Institute of Automation FPGA Correlator.

Report by Jeff Peterson

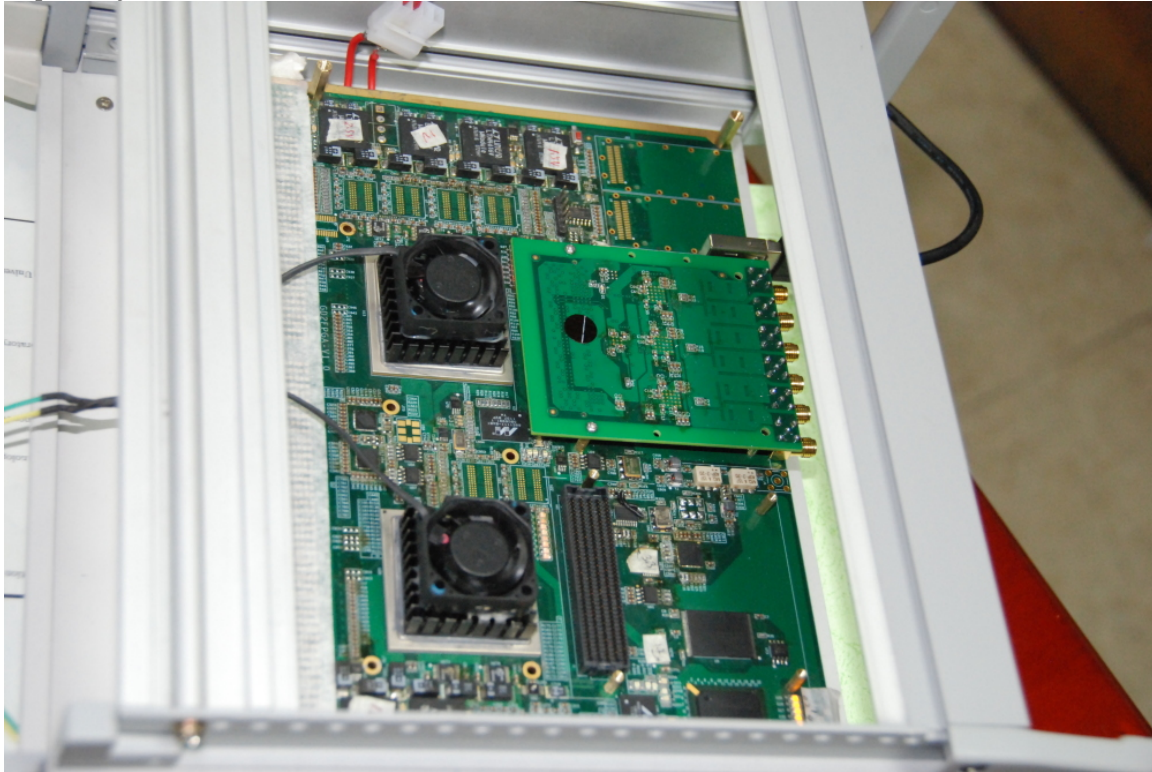
The board includes two Spartan Vertex 6 LX FPGAs, each with power supply set and FMC connector. Two unpopulated transceiver connectors are laid out on the upper right. These can be used for 10GbE. Looks like the transceivers connect to just one of the FPGAs. Is this enough bandwidth? Do we want two more on the other side? A USB port is provided. So far, the USB has been used for data transfers, and the Inst. has not built 10GbE data packets for this project.

One FMC daughter board with three dual-input ADCs is shown. No provisions appear to have been made to synchronize clocks or sample intervals. There are no SMAs for these signals.

The cooling of the unit proved inadequate and several ICs were damaged.
